M9806A-02

Information Only Service Note

M9806A PXIe Vector Network Analyzer

False alarm on self-test failure on firmware revision of A.13.40.02 - DDR3 memory removal

Self-test

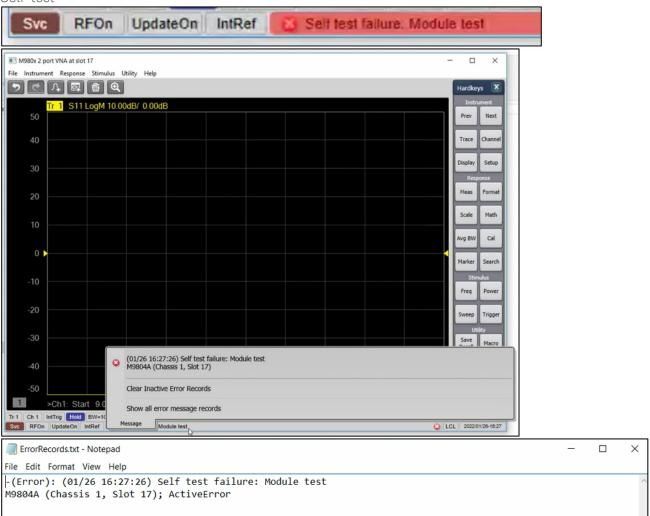
The on board DDR 3 memory in VNA is not in use since its release. With the removal of DDR 3 memory IC on newer M980xA VNA, right after firmware is launched, false alarm (self-test failure) will be reported as shown. This has no impact to VNA performance and specifications.

Similarly, firmware will report a false failure in Operator check. Shown are the error messages example on VNA firmware UI.

Since this DDR3 memory is not in use, newer firmware revision no longer consider it as the failure. Keysight recommends keeping VNA firmware up-to-date whenever it is possible.

For users with firmware revision of A.13.40.02, Update firmware to revision A.13.70.02 or newer to resolve this false alarm on self-test.
